This errata sheet provides updated information about known device issues affecting Arria® II GZ devices.

**Table 1. Issues for Arria II GZ Devices (Part 1 of 2)**

**Figure 1. Reference Clock Pre-Dividers in Transmitter PLLs**

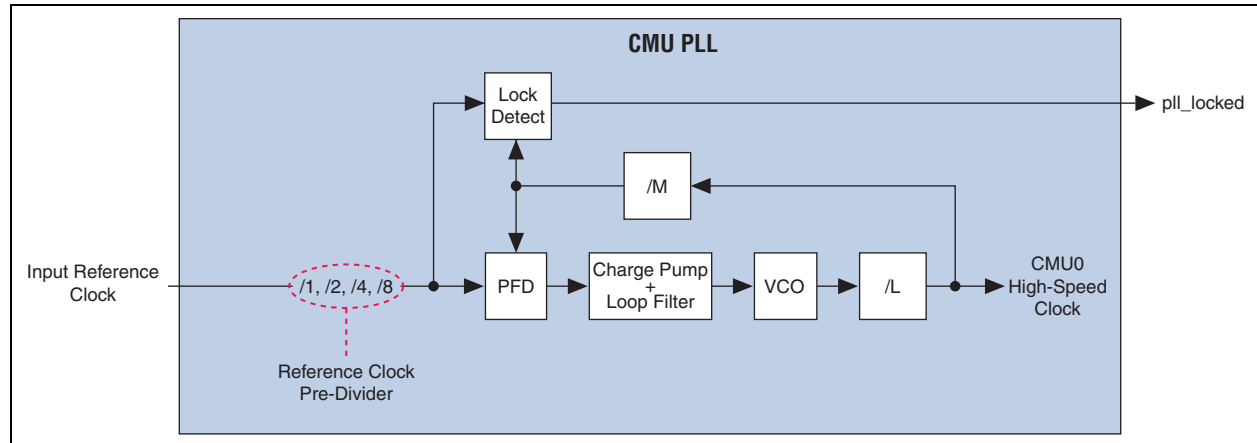
The transmitter phase-locked loop (PLL) lock status signal (pll\_locked) does not de-assert when the pll\_powerdown signal is asserted in configurations that use the reference clock pre-divider of 2, 4, or 8. Figure 1 shows the reference clock pre-divider inside transmitter PLLs. This issue impacts the pll\_locked status signal in the clock multiplier unit (CMU) PLL.

Figure 3. Instantiating and Connecting the pll\_locked\_soft\_logic Module

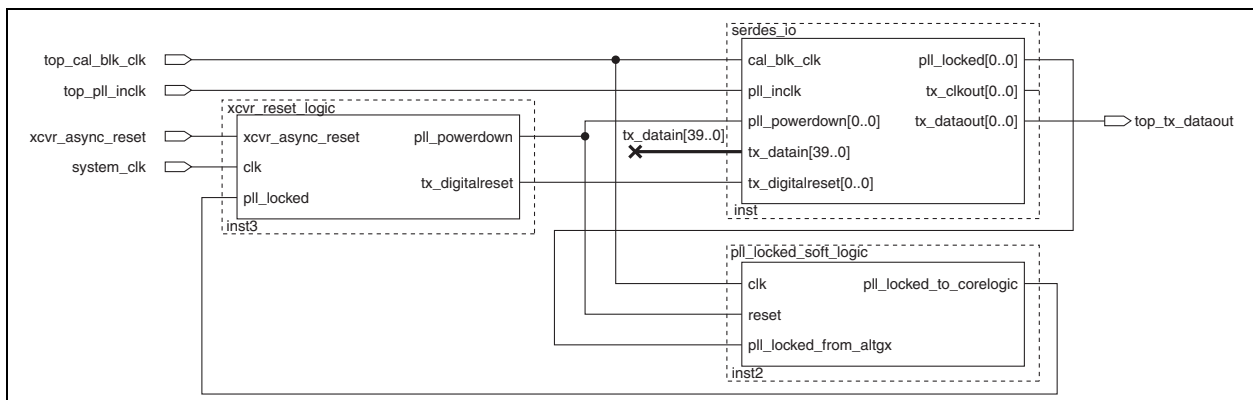
If the pll\_locked issue impacts your design, instantiate and connect the pll\_locked\_soft\_logic module, as shown in Figure 3. You must use the pll\_locked\_to\_corelogic output from this module in the transceiver reset logic and any user logic that relies on the transmitter PLL lock status signal.

Use the calibration block clock (`cal_blk_clk`) for the `pll_locked_soft_logic` module. The `cal_blk_clk` frequency specification ranges from 10 MHz to 125 MHz. Depending on your `cal_blk_clk` frequency, set the parameter `p_delay_counter` in `pll_locked_soft_logic` so that the delay is equal to 100  $\mu$ s (worst-case transmitter PLL lock time).
